Final Drainage Report
for
Windingwalk Filing 1
at
Meridian Ranch

EL PASO COUNTY, COLORADO

December 2017

PCD File No.'s PUDSP-18-002 and SF-18-002

Appendix D - Detention Pond Information

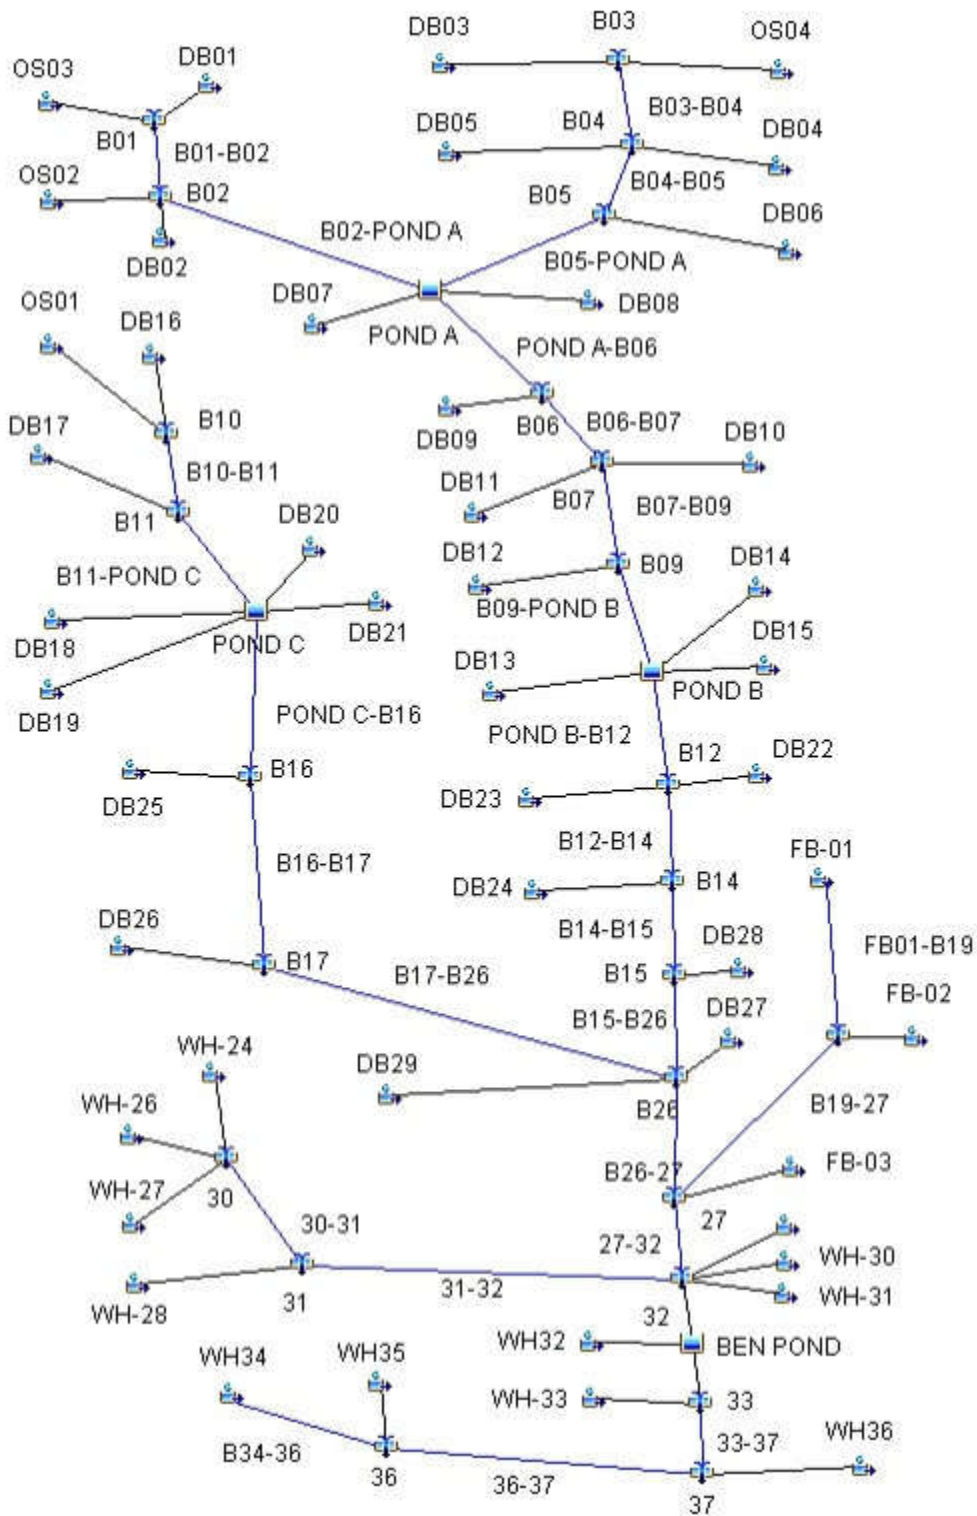
Replace the pond design calculations with the UD-Detention Worksheet. The WQCV seems small. Also drain time should be at 40hrs.

WQCV CORRECTED TO 40 HR FOR BOTH PONDS (E & H)

FIGURE 4

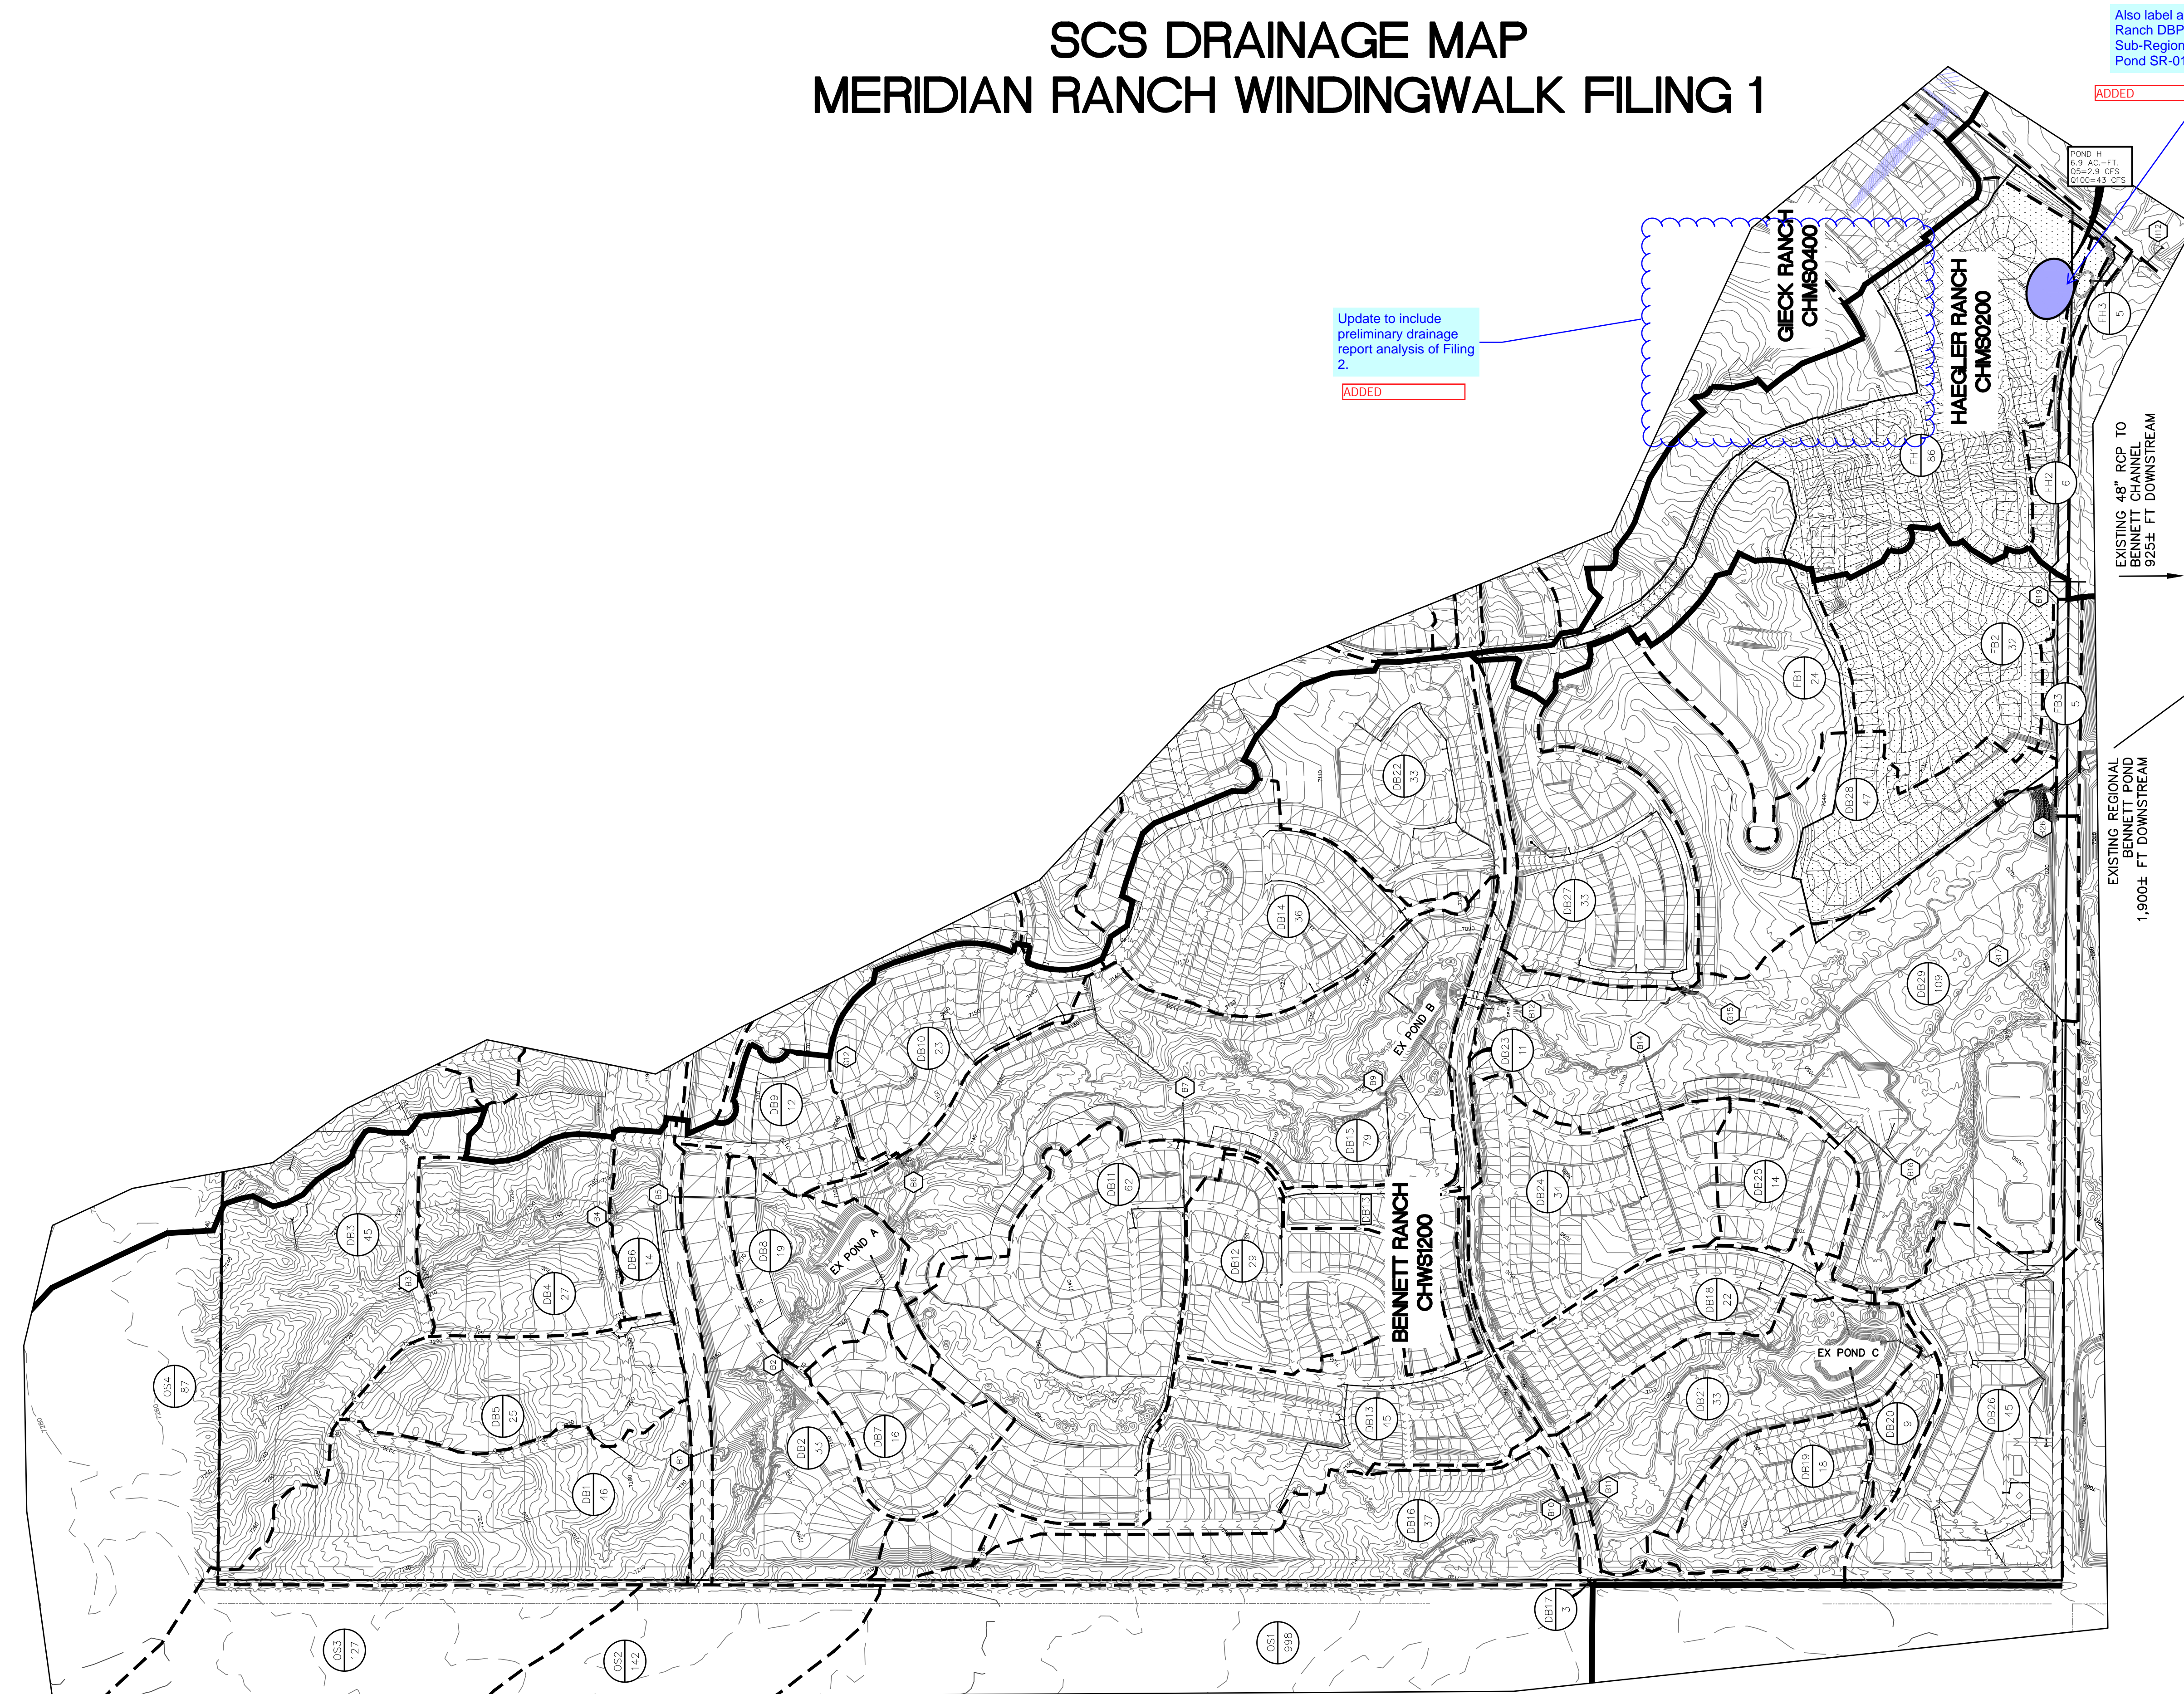
Since the drainage map only shows a portion of the SCS Hydrologic Element shown on this table, add a footnote referencing the MDDP (include the PCD Project No. if know) that provides the complete analysis.

| HISTORIC | | | | | | | |
|--------------------|-------------------------|--|--------------------------|--------------------------|--------------------------|-------------------------|-------------------------|
| HH01 | 0.0984 | REVISED MAPS TO SHOW DRAINAGE AREAS FROM STAPLETON NORTH | | | 0 | 3 | 0.0 |

S:\C:\p\proj\Winding Walk Filing 1\DWG\PLAN SHEETS\BASIN MAPS\FDR\FDR-WW1-SCS-FILING 1.dwg Fig 5: 12/12/2017 9:53:51 AM

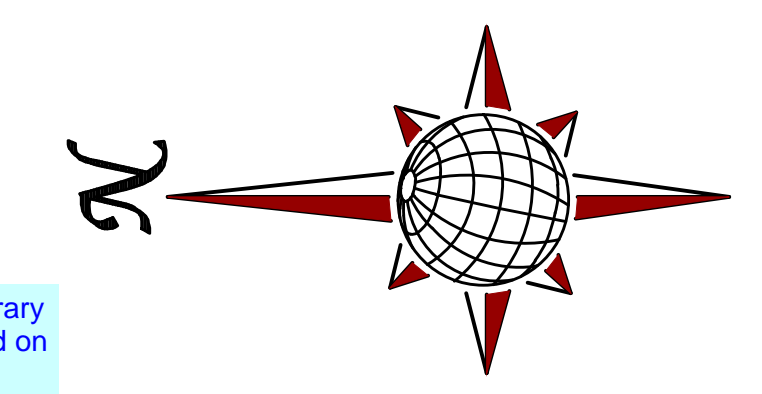
Drainage maps shall provide a summary of all minor and major flow rates at design points.
PROVIDED

Show and label the temporary sedimentation ponds noted on page 8

S:\C:\p\proj\Winding Walk Filing 1\DWG\PLAN SHEETS\BASIN MAPS\FDR\FDR-MW1-SCS-FUTURE.dwg, Fig 6, 12/12/2017, 10:03:46 AM

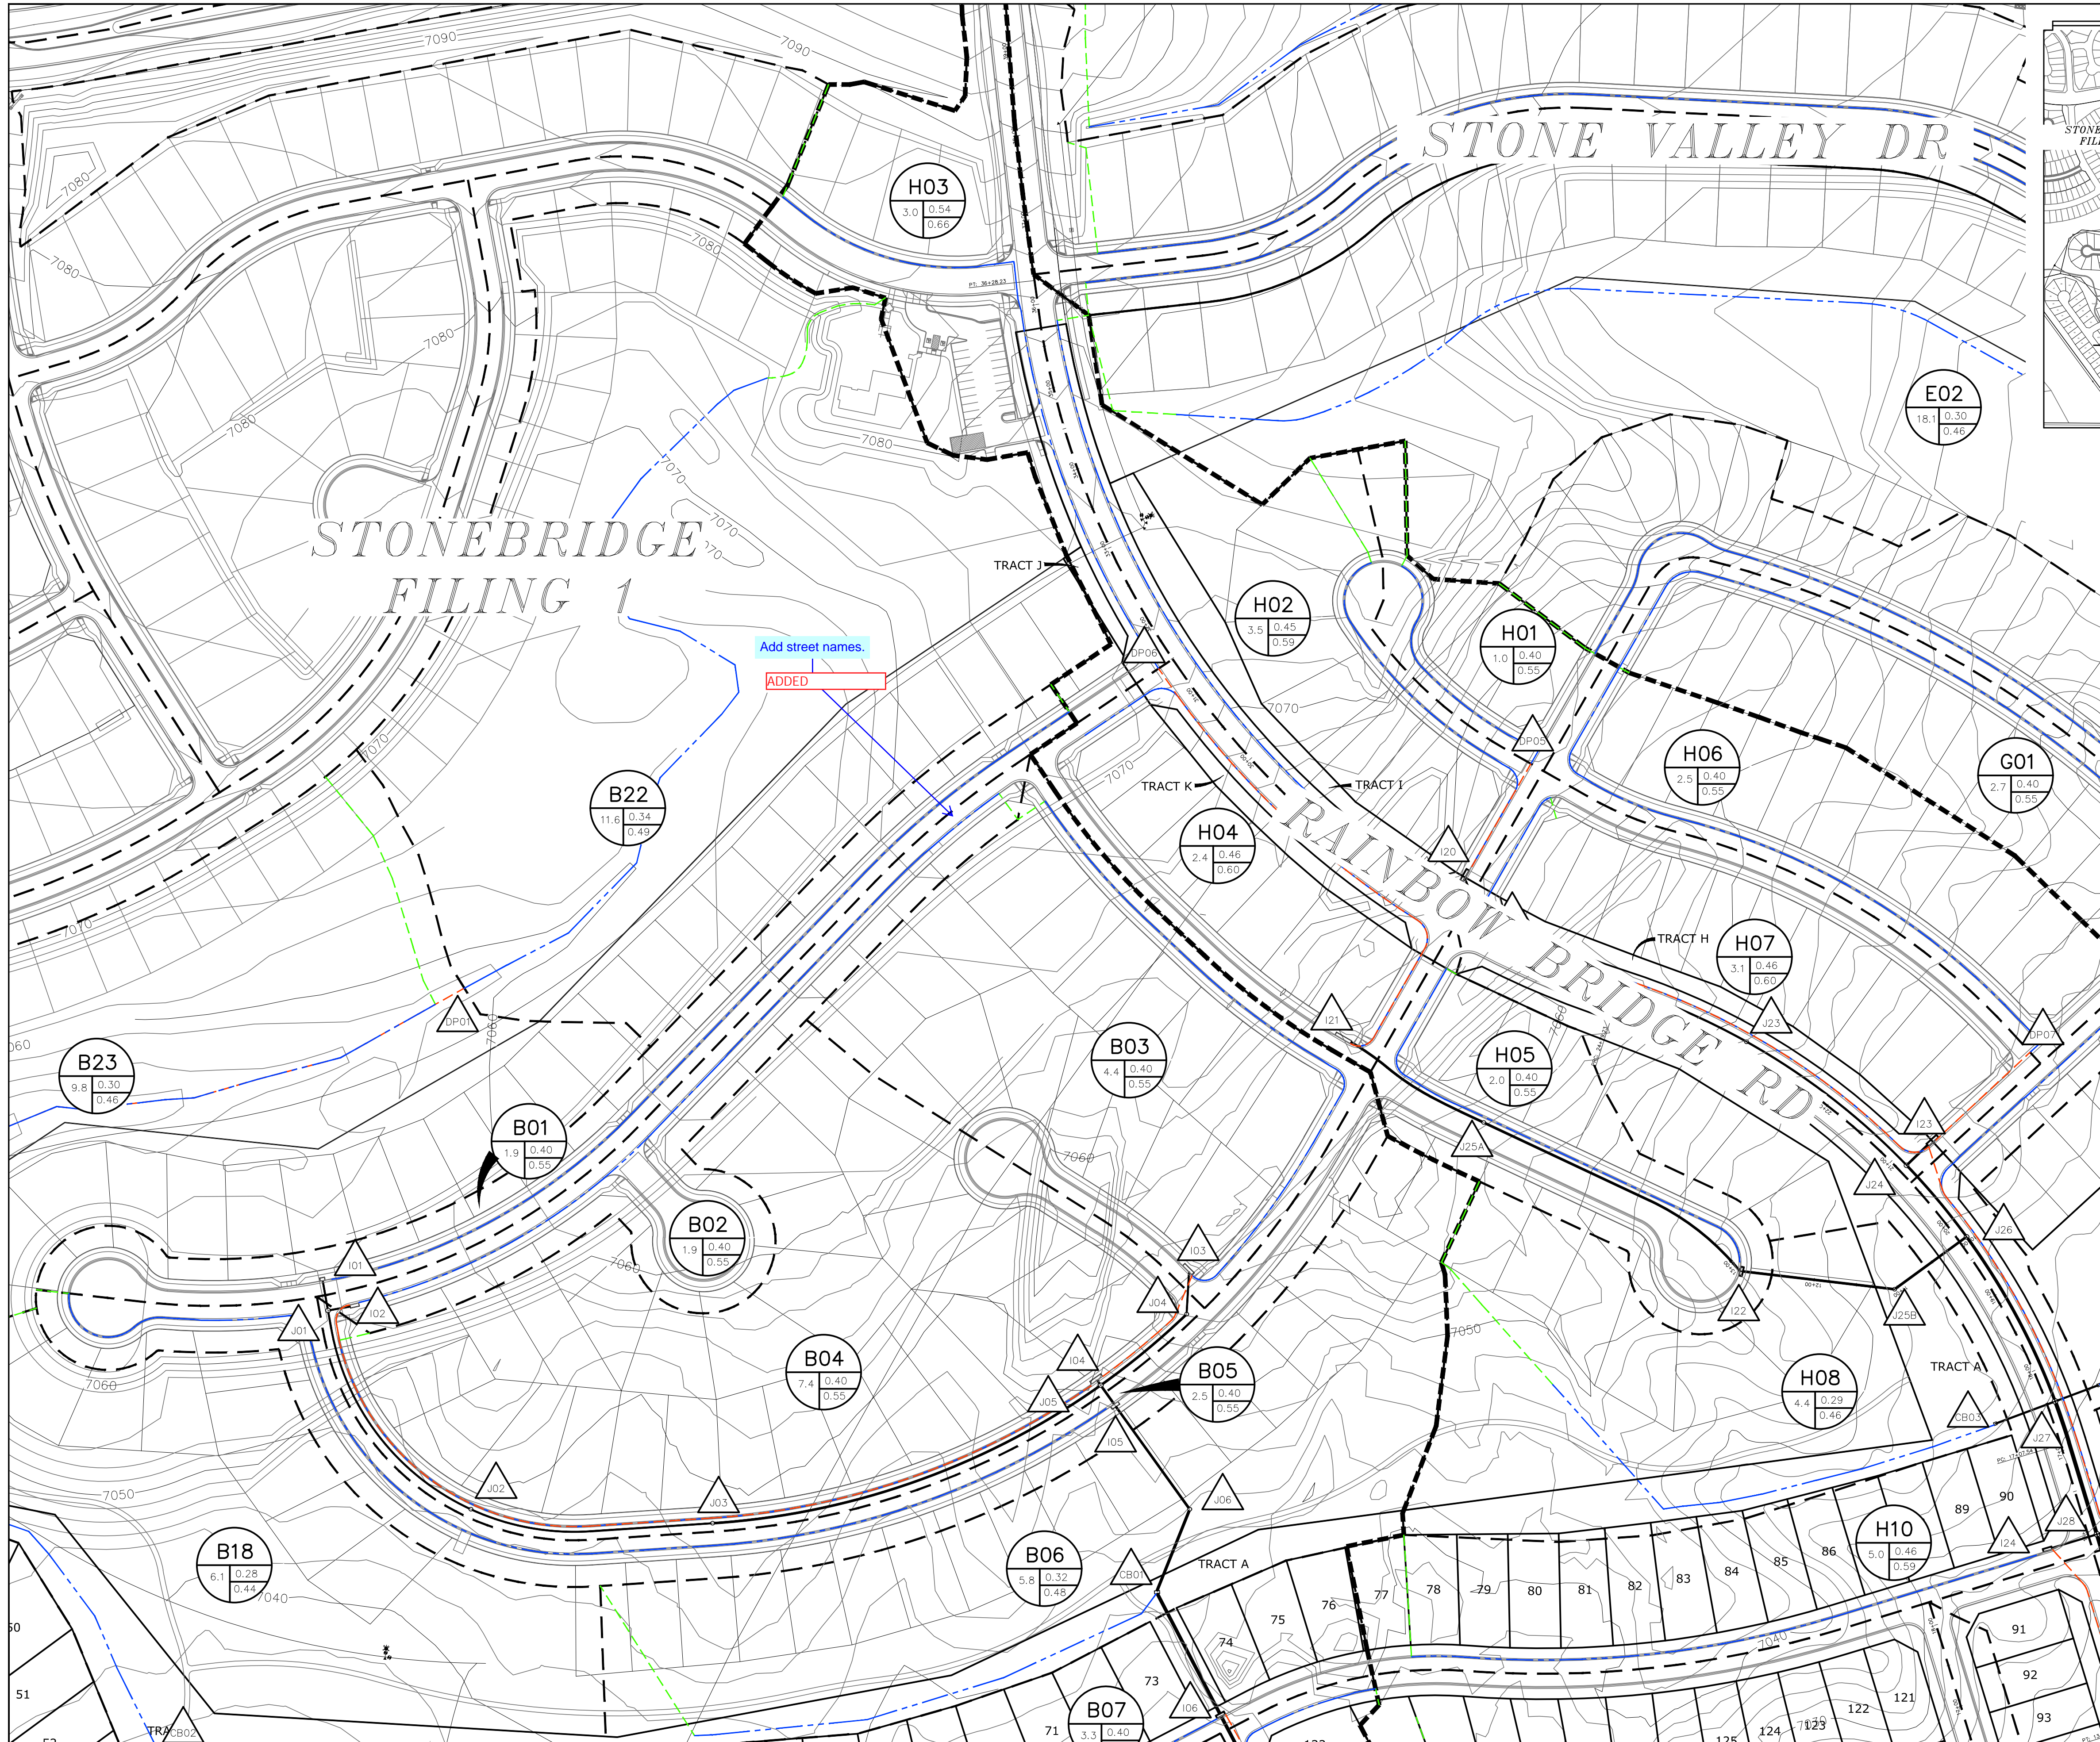
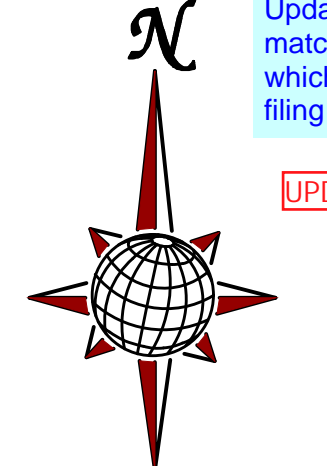
Update keymap to match the PUD which only shows filing 1 & 2
UPDATED

Add a summary of the minor/major flowrates at design points.
ADDED
